Plan Commission

Agenda

Monday, April 25, 2016

Item 4: Review and Recommendation on the Site Plan Application for De Pere Café, located at 1104 Honey Court (ED-1469). Applicant: Alliance Construction & Design

SHEET NO.
4

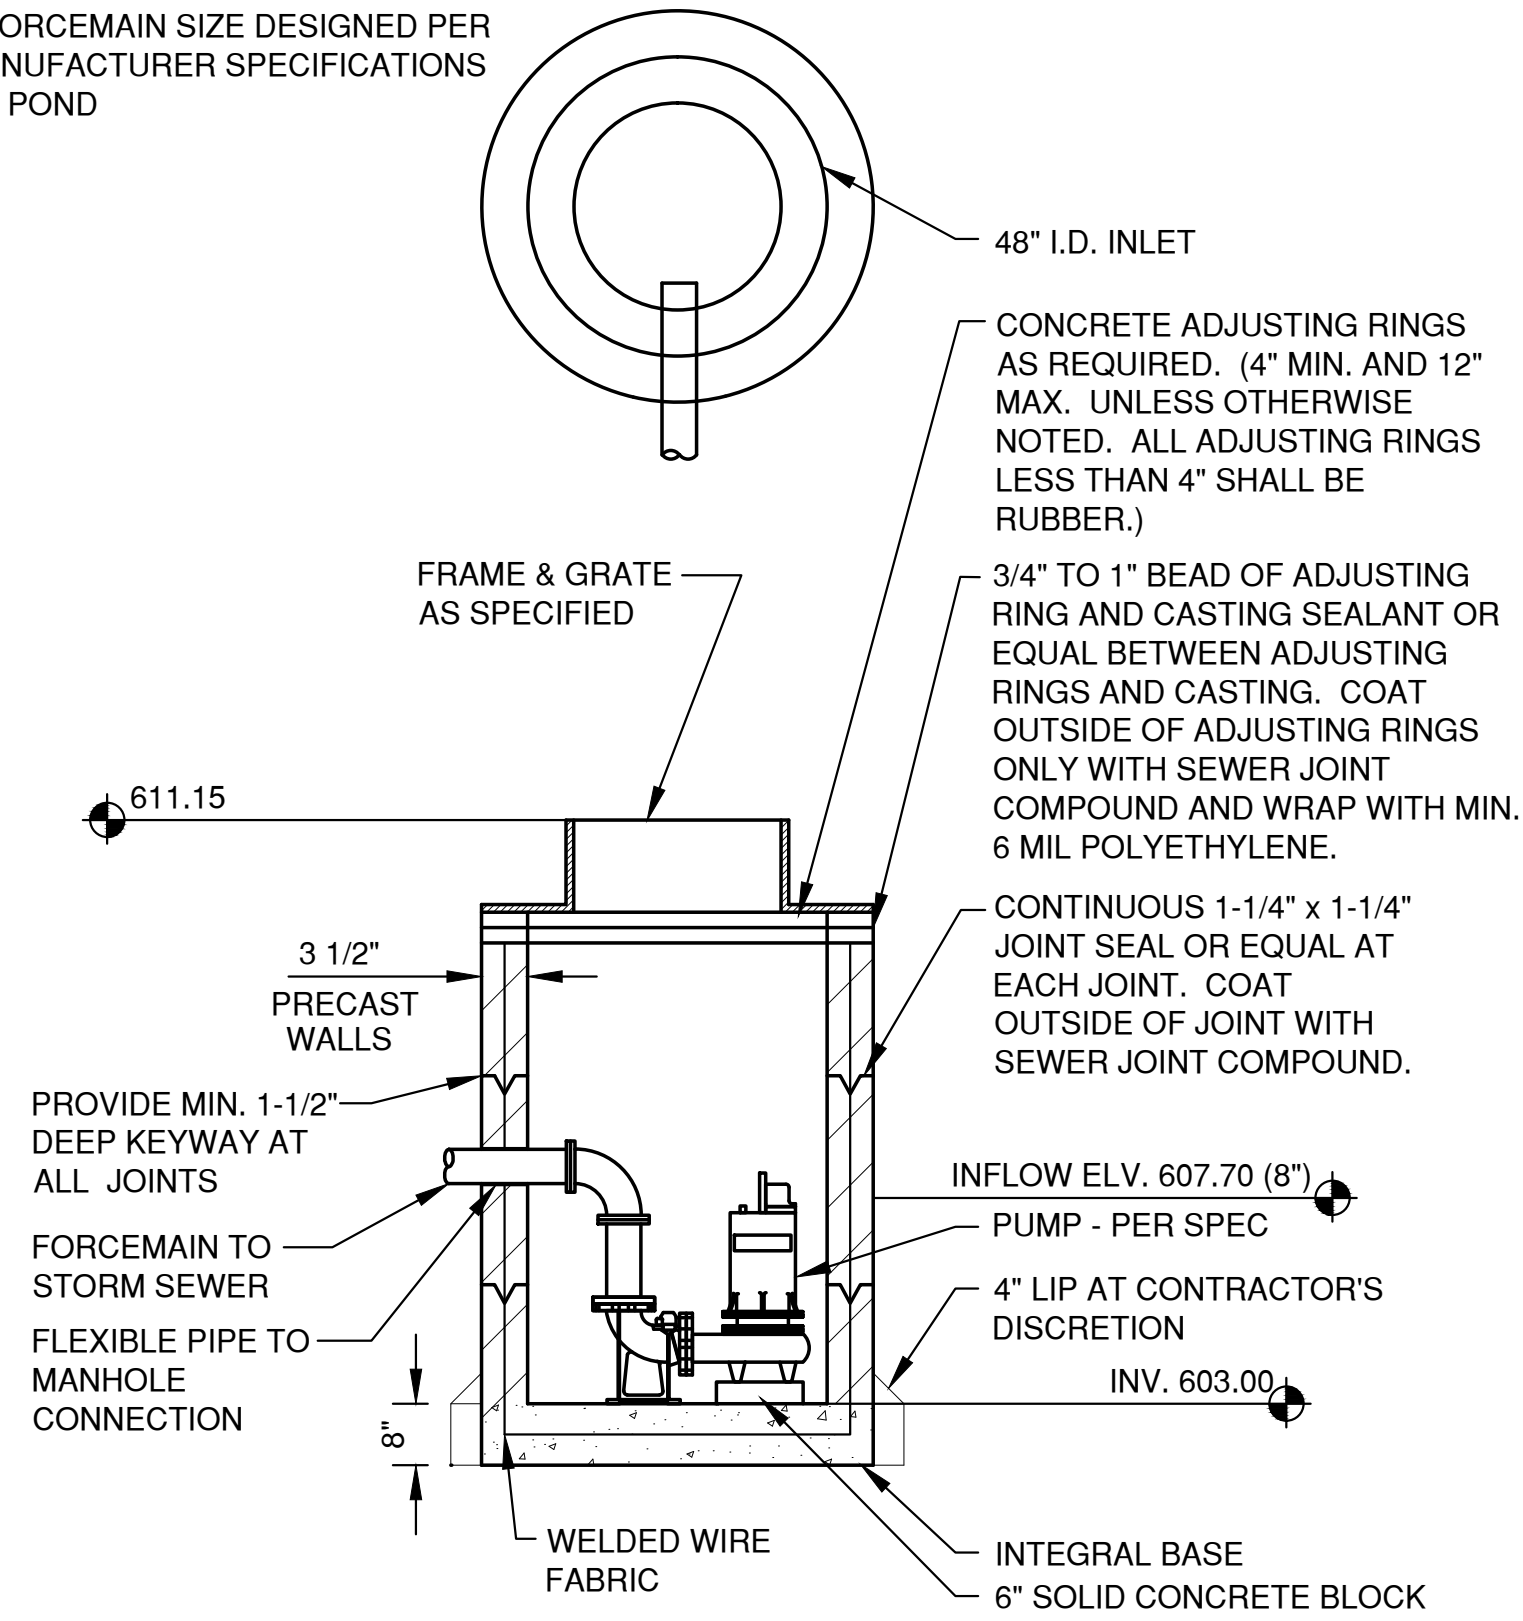
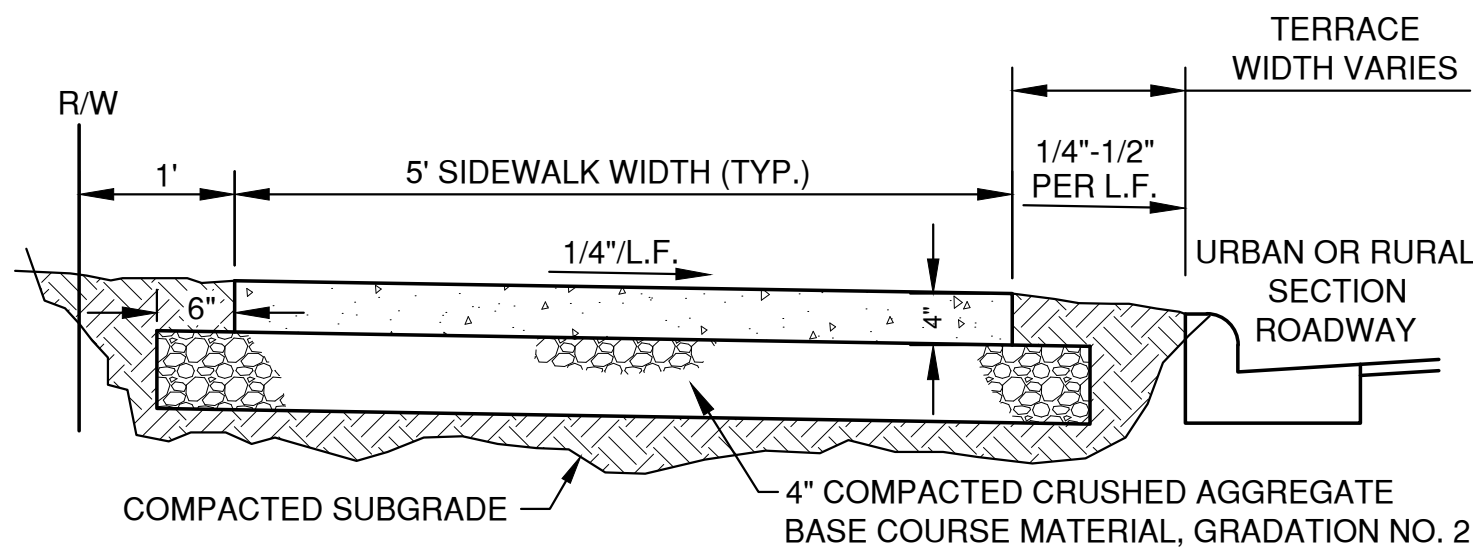
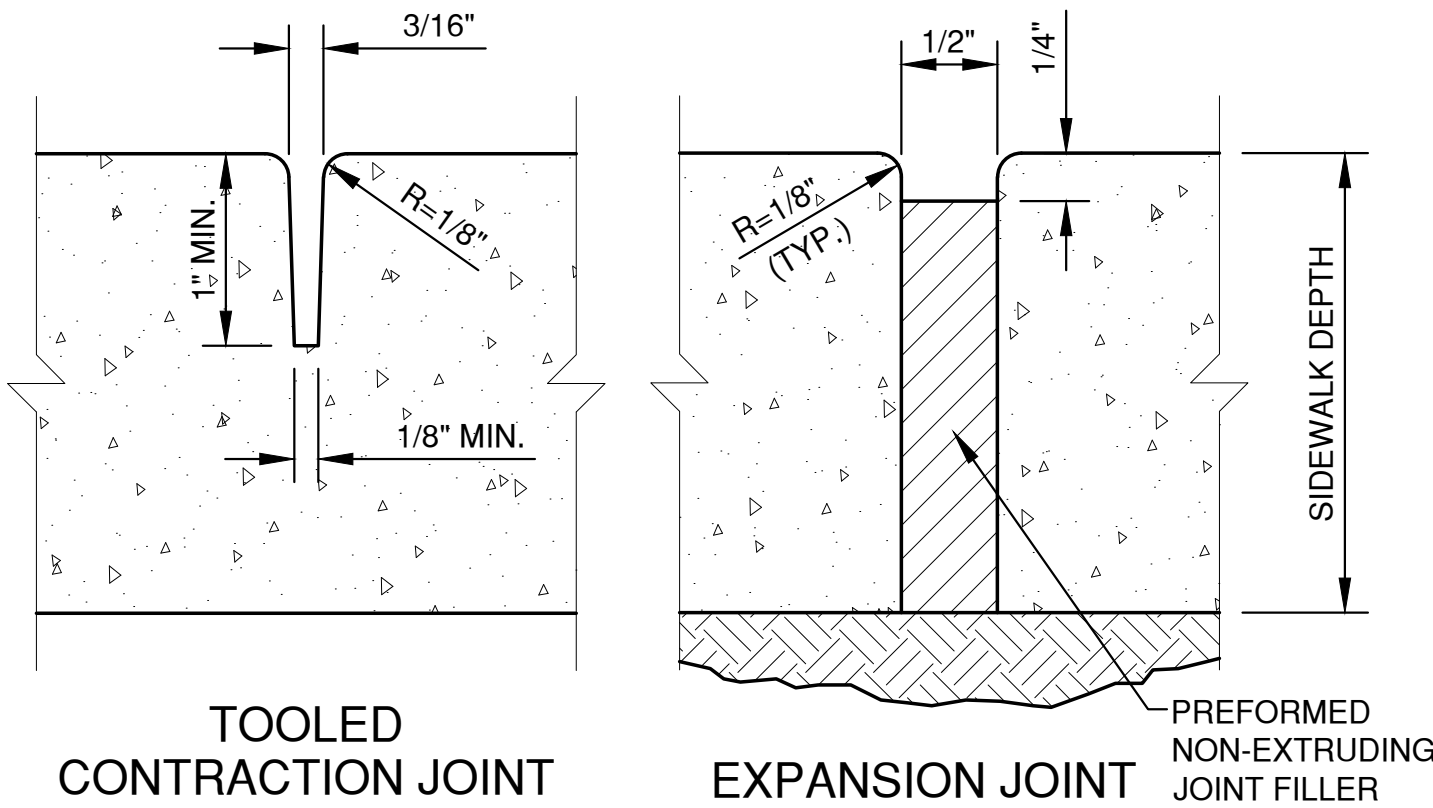
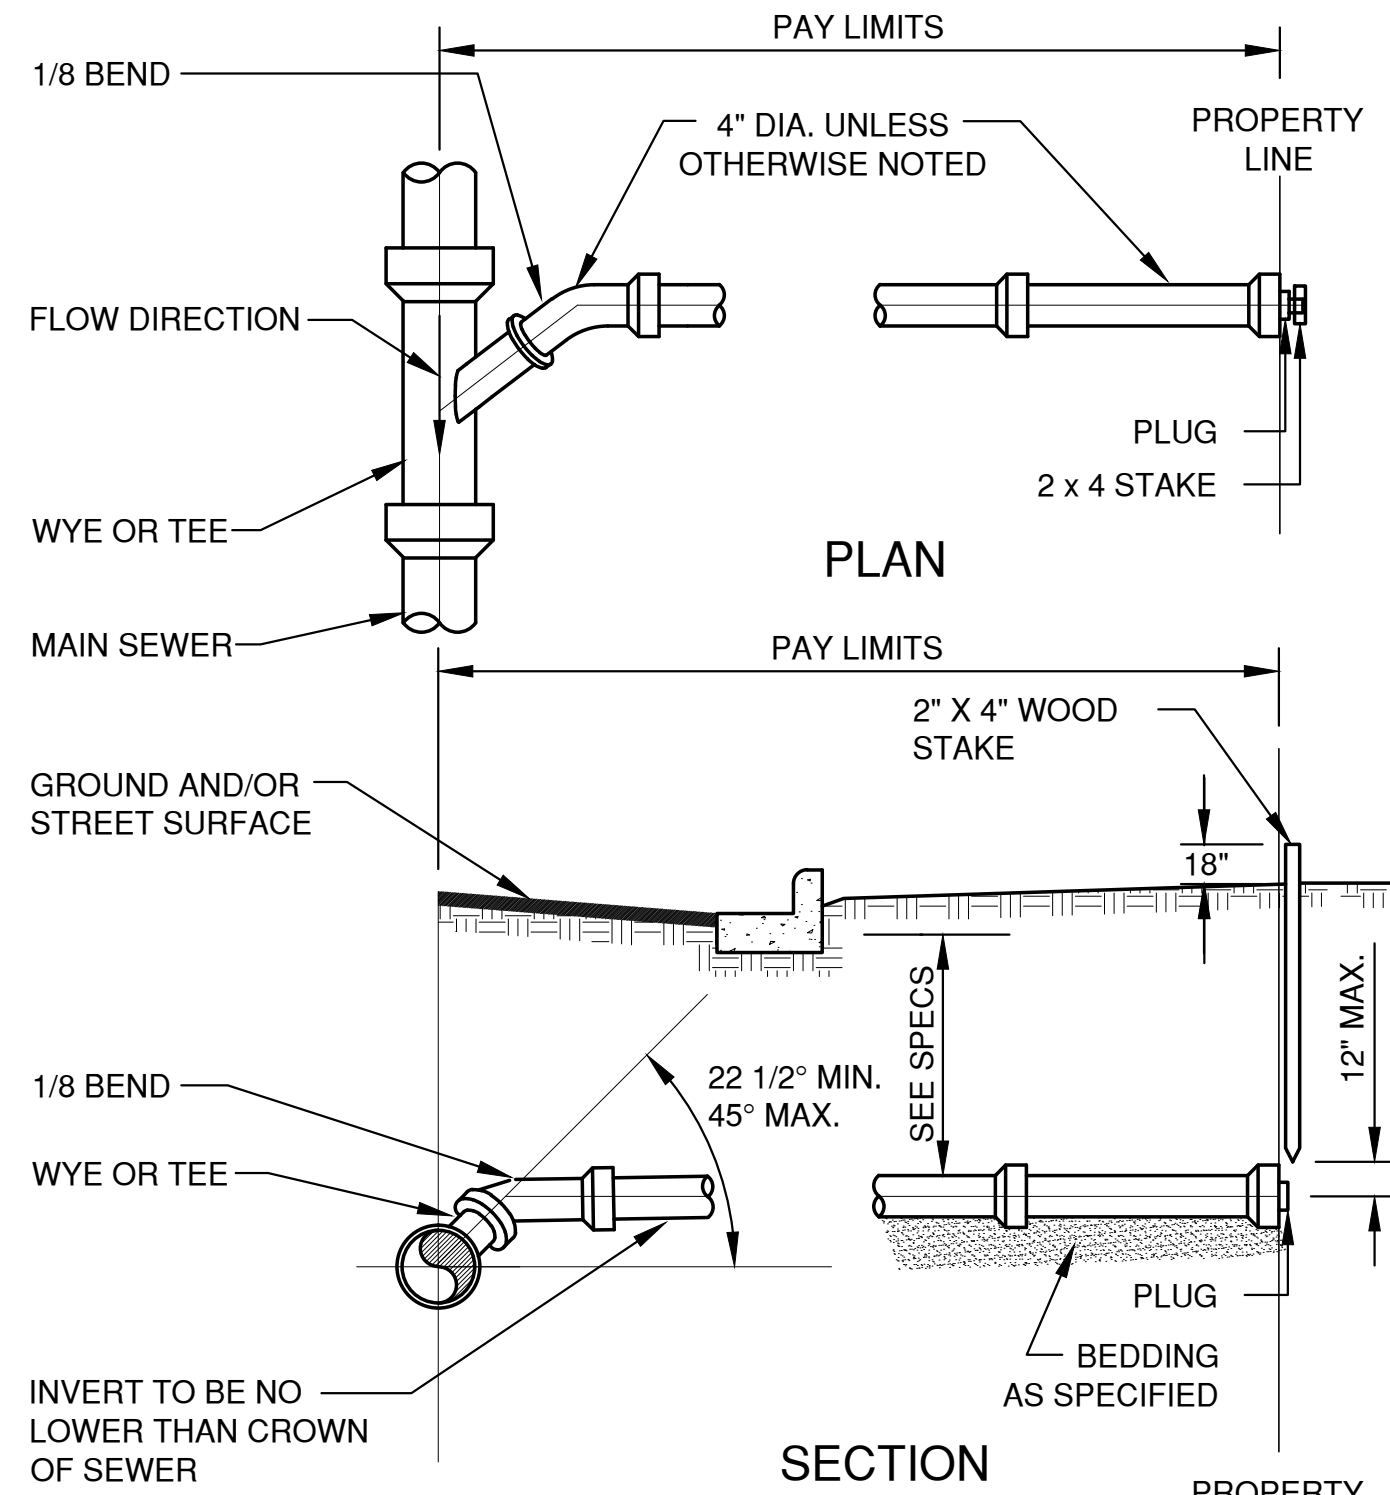
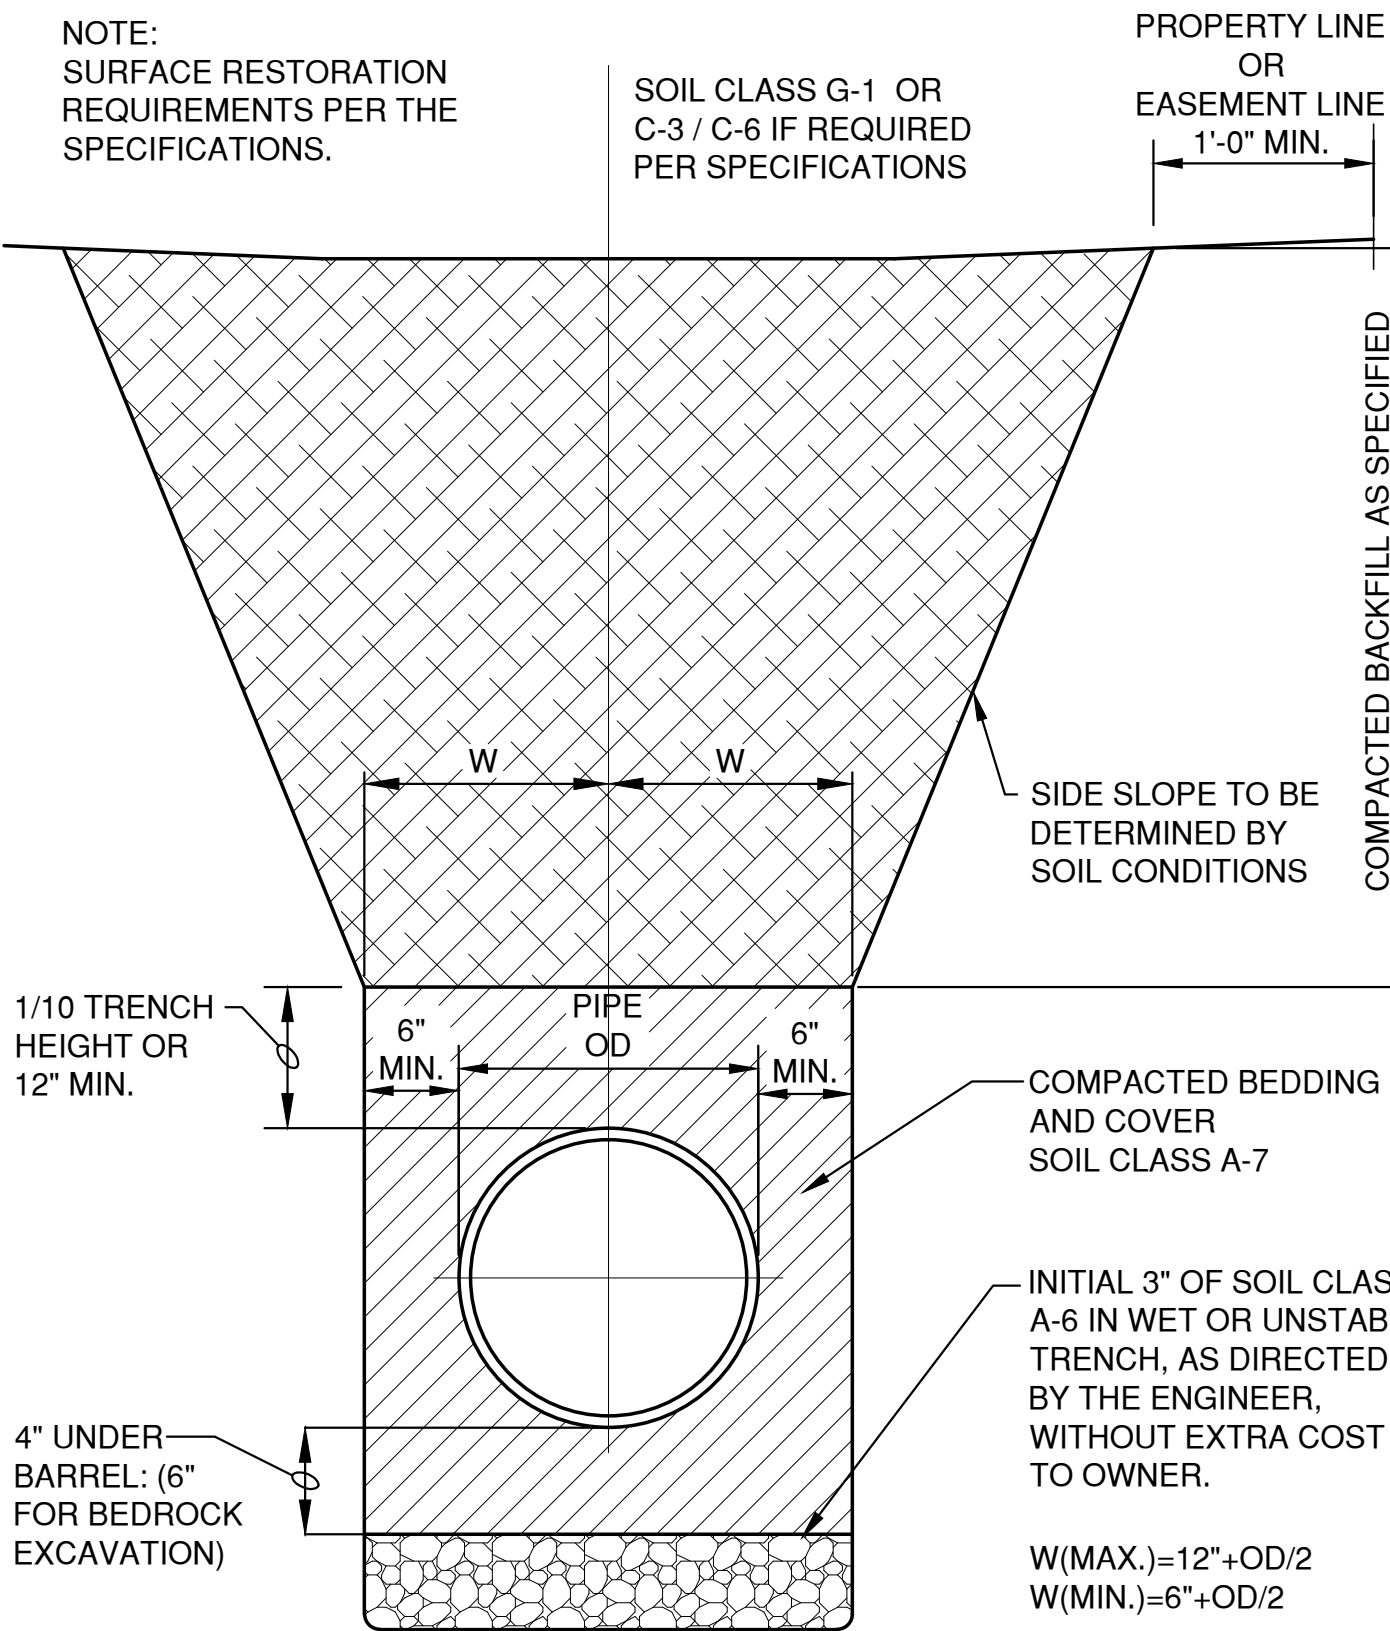
5. Curb cut permits are required for new driveways. Remove the curb removal details shown on sheet 4 of the plan. New curb will be required along the alley that complies with the City of De Pere Construction Specifications. Show the width of the driveway flares on the plan.
